CONNECTION ASSESSMENT & APPROVAL PROCESS

*Project: Replacement of 230kV Breakers
PL24 & KT22 at R.H. Martindale TS*

CAA ID No. 2002-EX025

HYDRO ONE NETWORKS Inc. MARTINDALE TS - Replace 230kV breakers PL24 & KT22

Breakers that are to be replaced

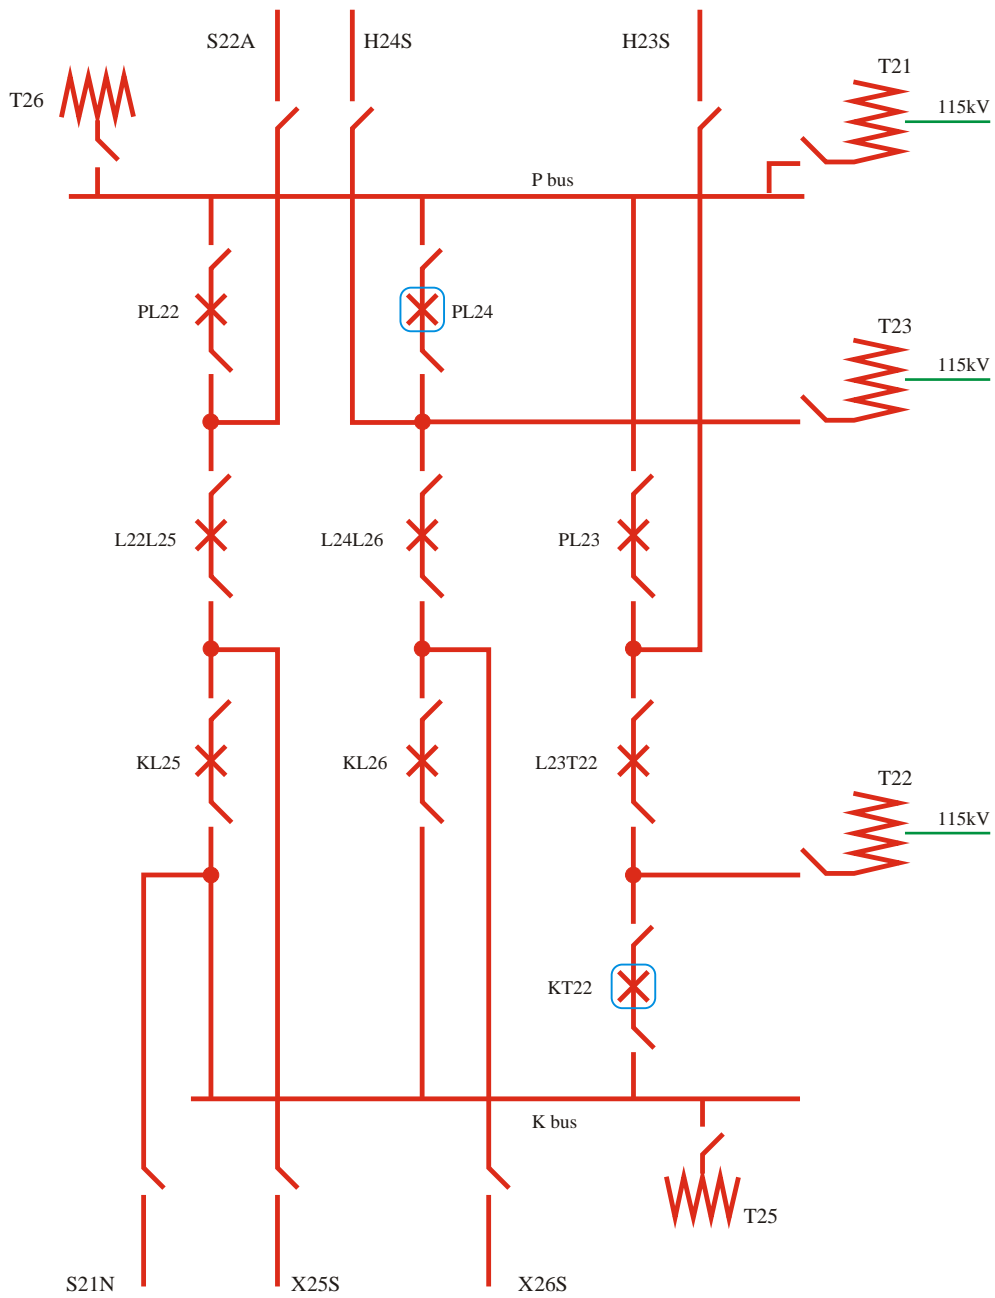
Following the replacement of breakers PL24 & KT22, three of the breakers at Martindale TS will be rated at 50kA, while all of the remaining breakers will be rated at 40kA. While the two replacement breakers will not comply with the Transmission System Code that requires a rating of 63kA for 230kV breakers, the new breakers will represent a marked improvement over the rating of 23kA for the existing breakers.

Once the two air-blast breakers at Martindale TS have been replaced, the minimum fault rating of the existing facilities at Martindale TS will then be 40kA, providing an additional margin of 17kA to accommodate any future increases in fault level. This is expected to be adequate for possible future developments, however should the fault level increase to above the 50kA rating of the new breakers due to developments by a third party, then the subsequent replacement of these two breakers would be expected to be undertaken at Hydro One's expense.

Since the replacement of breakers PL24 & KT22 at R.H. Martindale TS is considered to represent a like-for-like replacement of existing facilities, it will have no adverse impact on the IMO-controlled grid.

It is therefore recommended that a Notification of Approval of the Connection Proposal be issued.
